From: [Redacted]
To: [Redacted]
Cc: [Redacted]
Subject: RE: WID13479 - SCOP 0049 - Thistle Wind Partners Limited - Ayre Offshore Wind Farm - Scotwind NE2 site - Scoping consultation - Response required by 3 August 2024
Date: 01 August 2024 16:35:24
Attachments: [image003.png](#)
[image004.png](#)
[image006.png](#)

Thank you for the opportunity to comment on the Ayre Offshore Wind Farm applications.

Thank you for the opportunity to comment on the applications for consent under Section 36 of the Electricity Act 1989 and marine licences under the Marine (Scotland) Act 2010 for the Ayre Offshore Wind Farm.

Our advice in this letter is in relation to the Ayre Array Area, the Export Cable Corridor (ECC) and landfall (up to Mean High Water Springs (MHWS) only), hereafter referred to as the Proposed Development. Onshore components will be subject to separate terrestrial planning applications.

OUR REF; WID13479

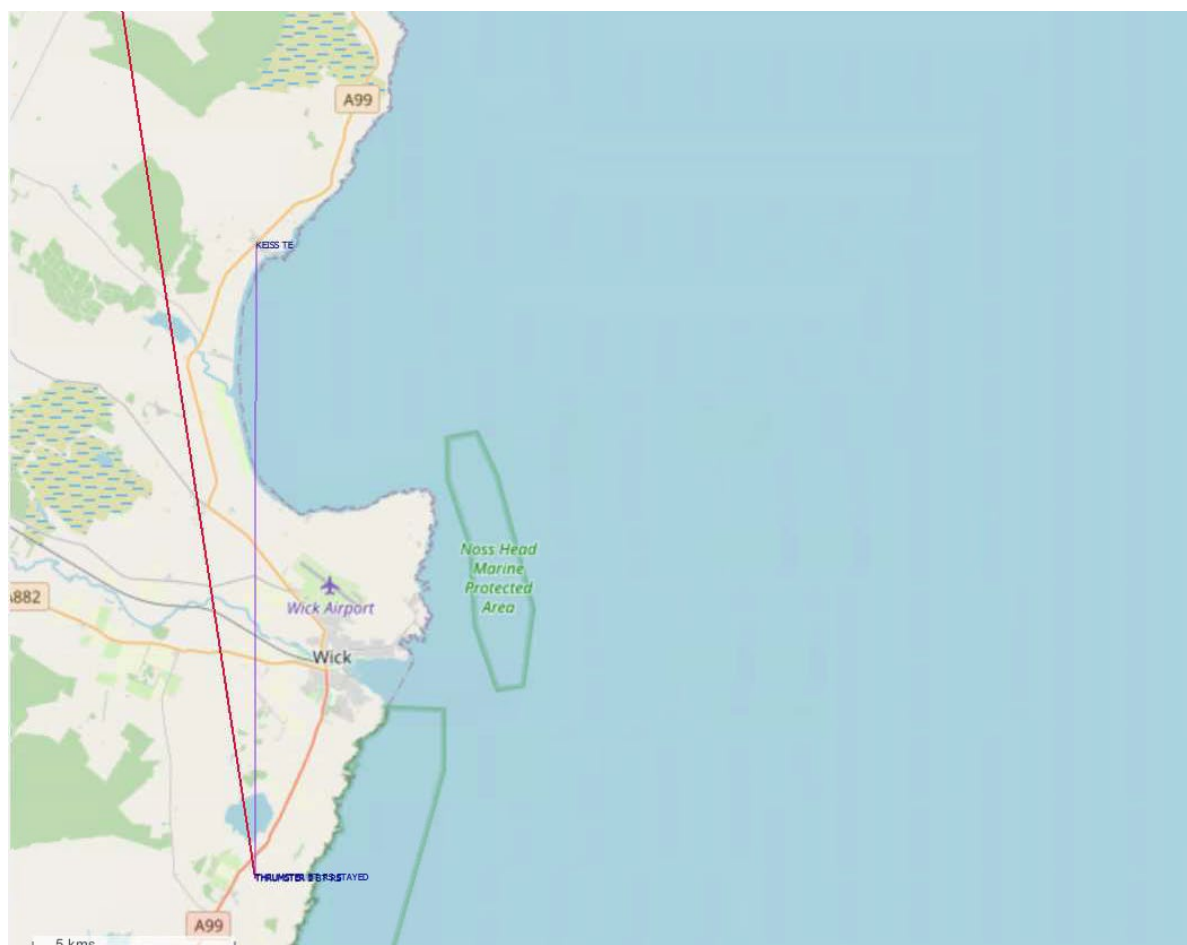
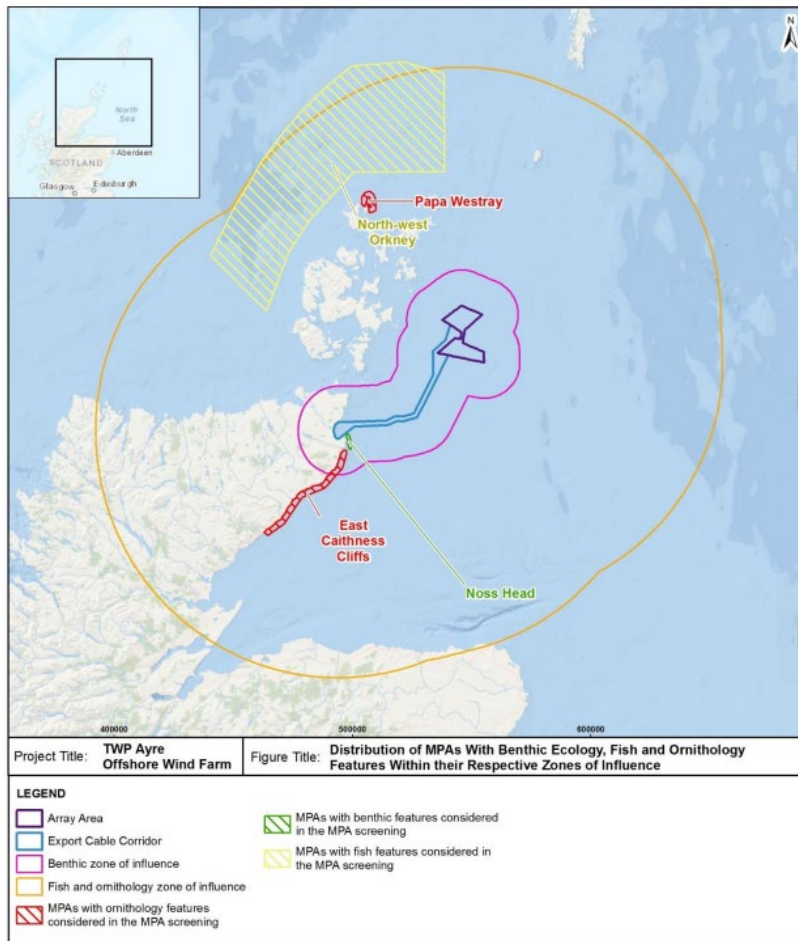
We have studied this Thistle Wind Partners Limited Ayre Offshore Wind Farm scoping proposal with respect to EMC and related problems to BT point-to-point microwave radio links.

The conclusion is that, the project indicated should not cause interference to BT's current and presently planned radio network.

BT requires 100m minimum clearance from any structure to the radio link path. If the proposed locations change, please let us know and we can reassess this for you.

OUR REF; WID13479

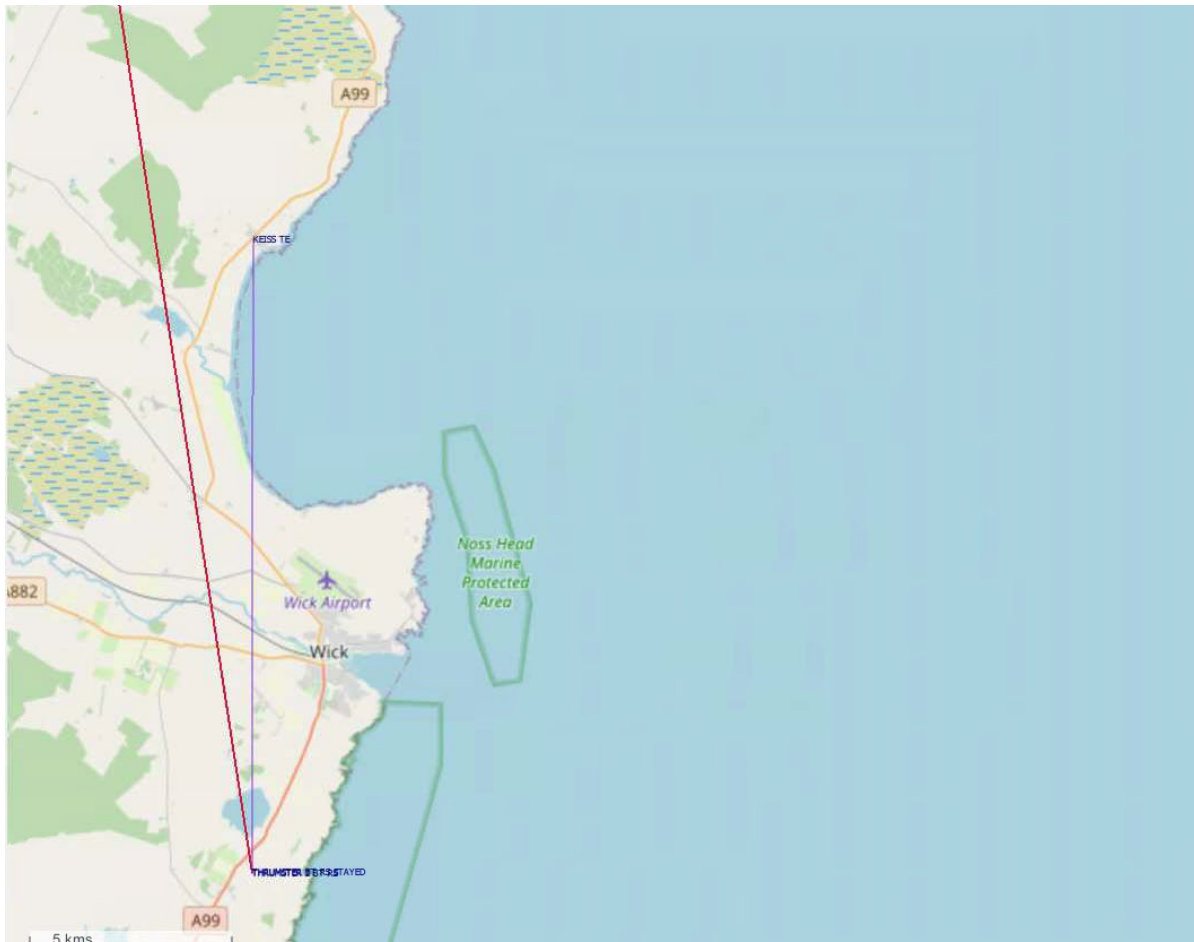
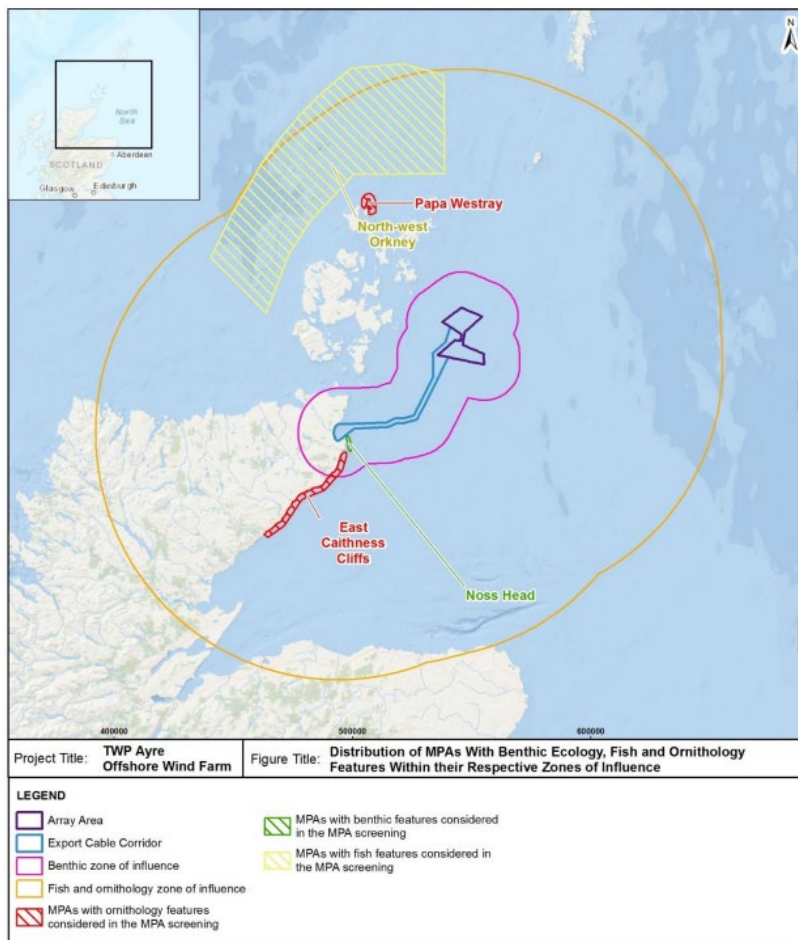
We have studied this Windburn Wind Farm scoping proposal with respect to EMC and related problems to BT point-to-point microwave radio links.

The conclusion is that, the 'Array Area' indicated should not cause interference to BT's current and presently planned radio network.

BT requires 100m minimum clearance from any structure to the radio link path. If the proposed locations change, please let us know and we can reassess this for you.

F.7.1 Great northern diver

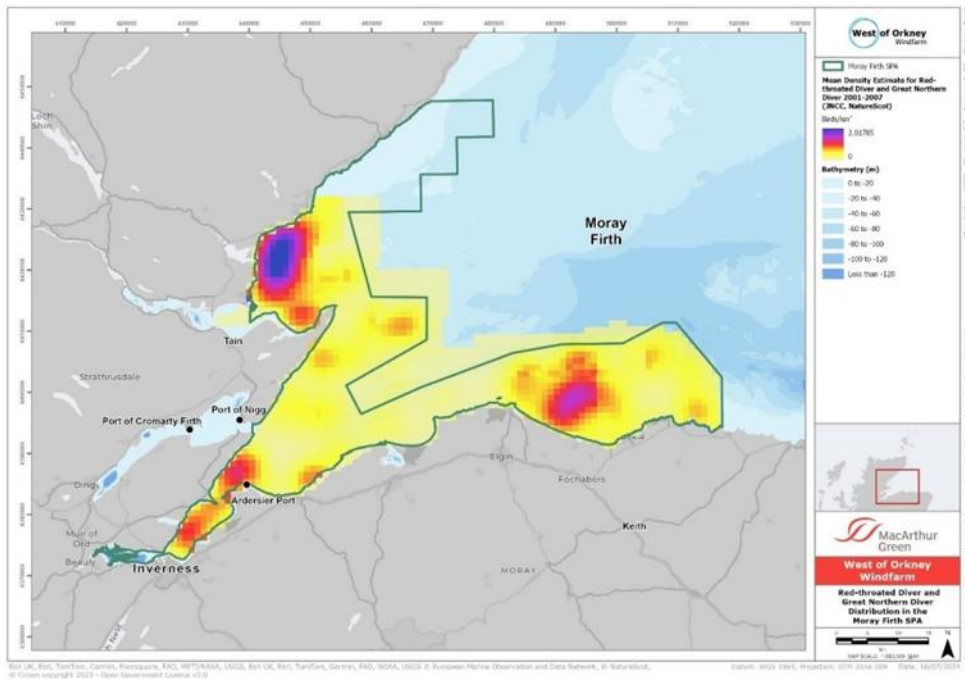
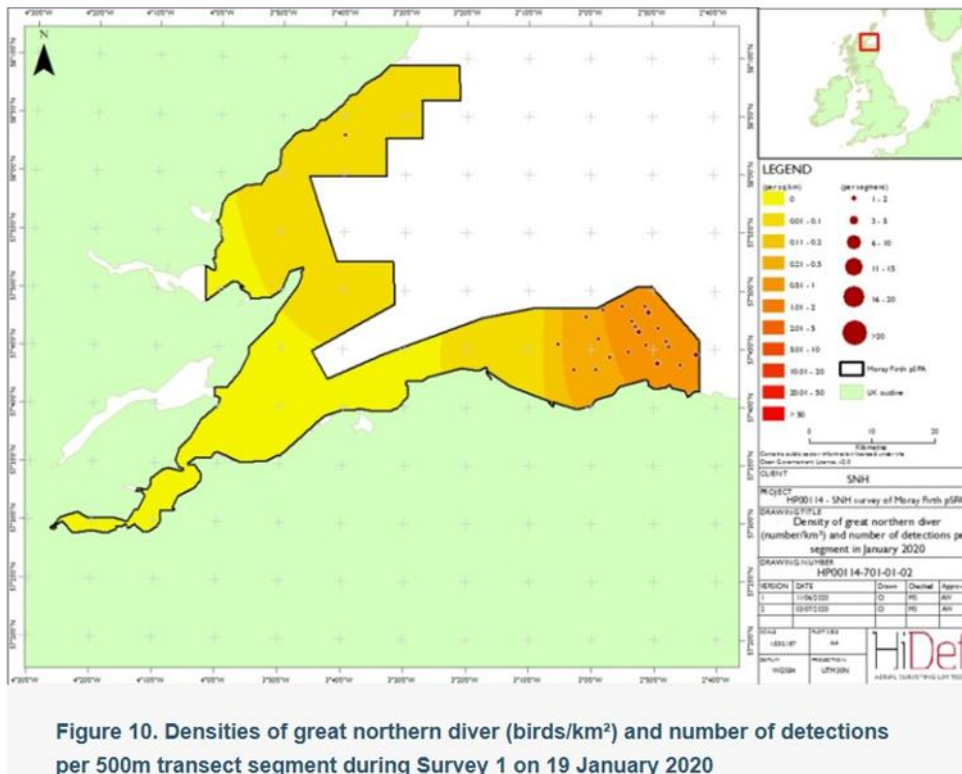
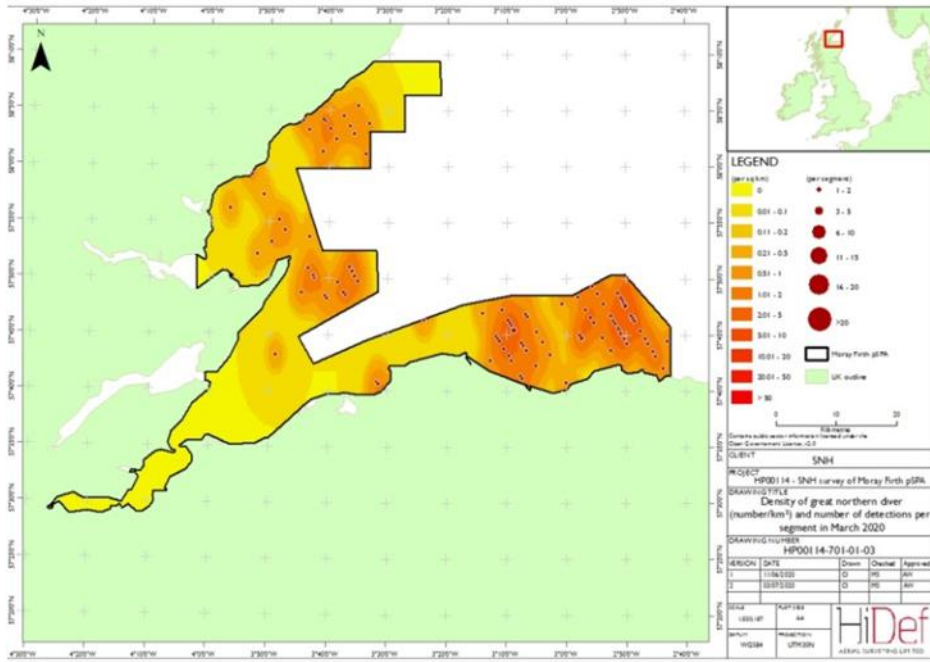
The 2020 survey results shown above did not indicate any significant densities of great northern divers in the vicinity of any of the ports. However, the March 2020 survey did indicate some higher densities of birds on the proposed route heading north, near the entrance to, and north of, the Dornoch Firth. It is likely that vessel disturbance of aggregations of divers could occur in this area.

F.7.2 Red-throated diver

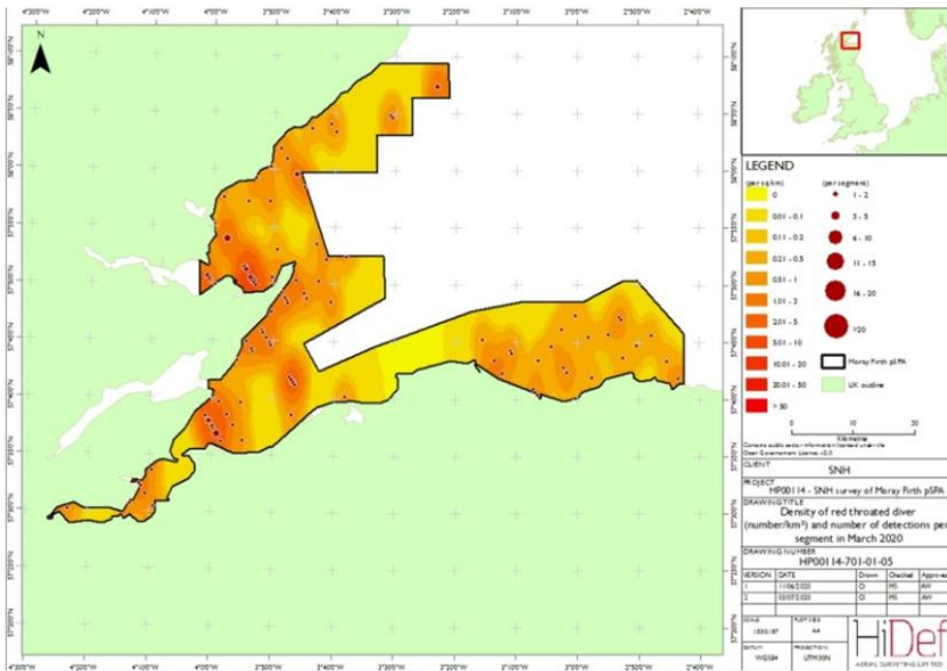
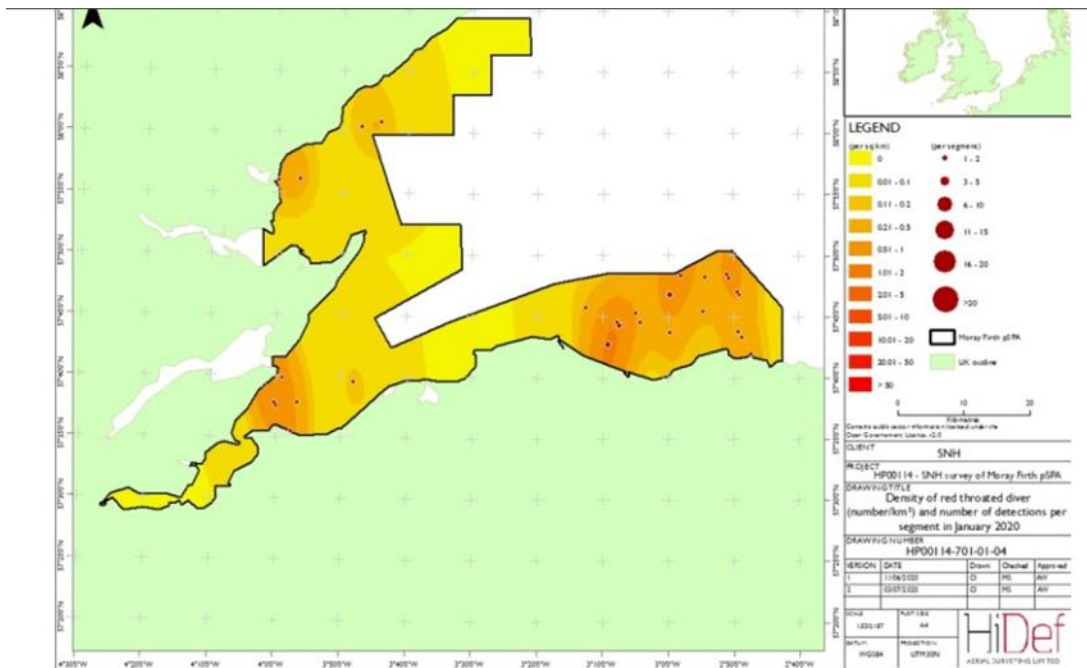
The 2020 survey results shown above, especially the March survey, indicate areas of higher densities of divers in the vicinity of the ports and along the route north through the SPA.
